Addendum 1
March 2007

Specification for Rotary Drill Stem Elements

ANSI/API SPECIFICATION 7-1
FIRST EDITION, MARCH 2006

Addendum 1 to Specification for Rotary Drill Stem Elements

Figure 11 — Dimensions of Heavy Weight Drill Pipe

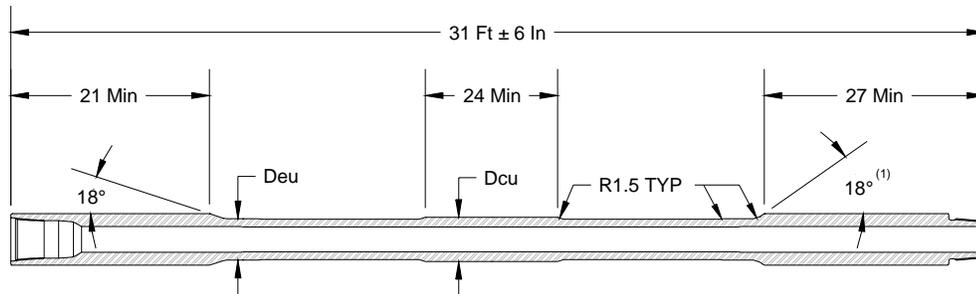
Add the following new Clause 10. Renumber the current Clause 10 Nondestructive examination of bars and tubes and sub clauses as Clause 11.

Heavy Weight Drill Pipe (HWDP) shall be furnished in the sizes and dimensions shown in Table 27 and as illustrated in Figure 11.

- 1 35 degree taper on the pin end at the manufacturers option.
- 2 All dimensions are in inches, except as noted.
- 3 The center upset shall be located approximately mid length of the tube.

Note – The above dimensions apply to both integral and welded Heavy Weight Drill Pipe.
